Request for Review UNFCCC, dated October 03th 2007 for the CDM Project 1235
Rio Grande do Sul Cooperatives Small Hydro Power Plants

Review Form 4 dated 03 October 2007

Figure 1 - Bloomberg Screen – Brazil 30 year Bond

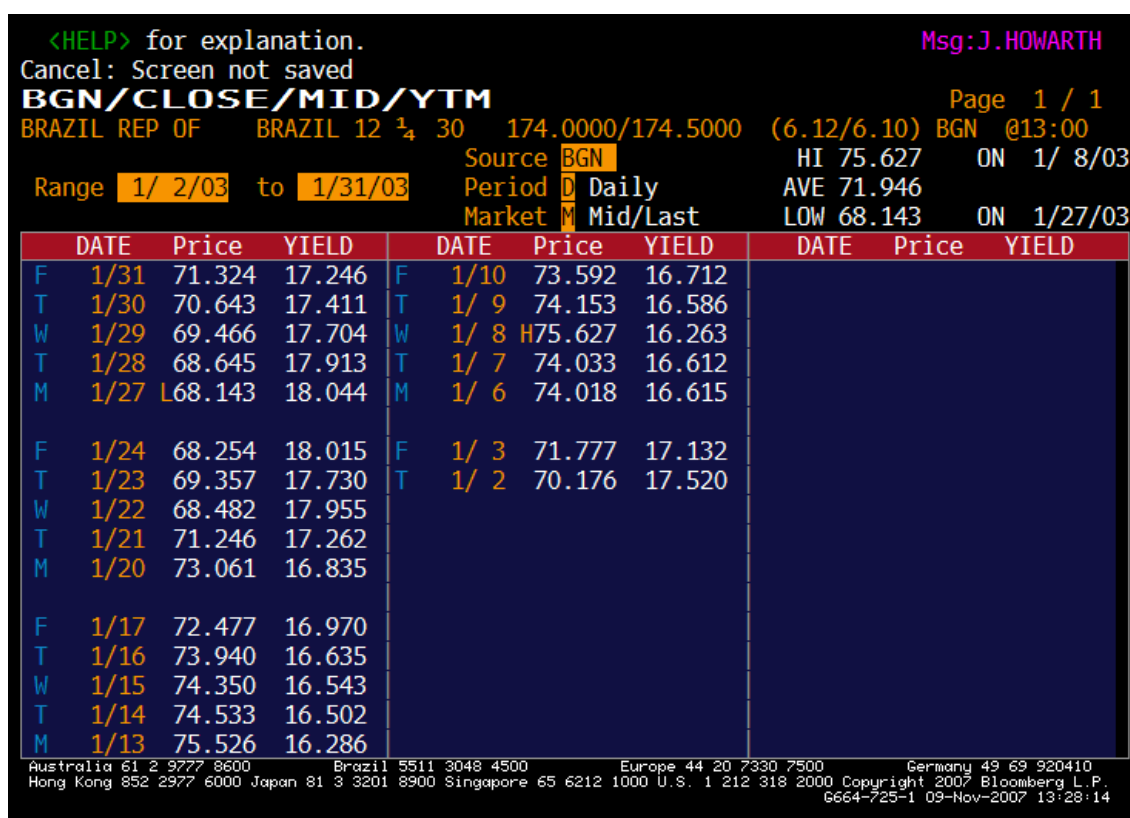
3. The PDD states that “It is important to notice that the direct comparison between the SELIC rate and the IRR is not accurate and the idea is not to introduce a benchmark analysis, but to set a parameter as a reference”. However the SELIC reference rate is not appropriate as the projects have been partly financed with a long term loan at a lower rate than the short term market rate used as a reference.

The Cooperativas bundle of projects was developed with corporate guarantees posted by the sponsors and financed by BNDES. At the time of project inception, the long term loan provided by BNDES was indeed below the SELIC rate. In spite of that, the BNDES financing rate available to Cooperativas should not be used as a parameter to assess the project attractiveness. The relevant parameter for an investor seeking financial return is the project yield after interest and principal of long term debt is repaid. In other words, if the project return on investment or the investor's internal rate of return (IRR) for a particular project is above capital market returns of similar risk, then it is expected that the sponsors will decide to invest their capital in the project. At the time of project inception, the sponsors had the alternative to invest in debt instruments of similar maturity to the hydro plants concession. For instance, instead of building

the three power plants, the project sponsors could have used their capital to invest in the 30-year dollar denominated Brazil sovereign bond maturing in 2030. As shown in Figure 1, at the time of project inception, the average yield of the Brazil-30 bond was approximately 17%p.a. in US dollars (source: Bloomberg). Assuming an inflation rate differential of 5% (source: Central Bank of Brazil) between the Brazilian currency, the Real, to the US dollar, the adjusted yield in Real for the 30-year sovereign bond was approximately 22%p.a. Given the expected return on investment for each one of the three projects: Cascata das Andorinhas (IRR of negative 7.5%p.a.), Caraguatá (IRR of 6.2% p.a.) and Linha Três Leste (IRR of 14.6%p.a.), the project sponsors should rather have invested in Brazilian bonds instead of building the power plants. The real magnitude of CDM revenues available to investors was unknown at the time of project inception, however, the fact that the sponsors could count on another source of revenues to increase expected project yield, compensated for the additional risk to invest in the three power plants. In sum, in the absence of CDM, Cooperativas would be a riskier and marginally attractive project.
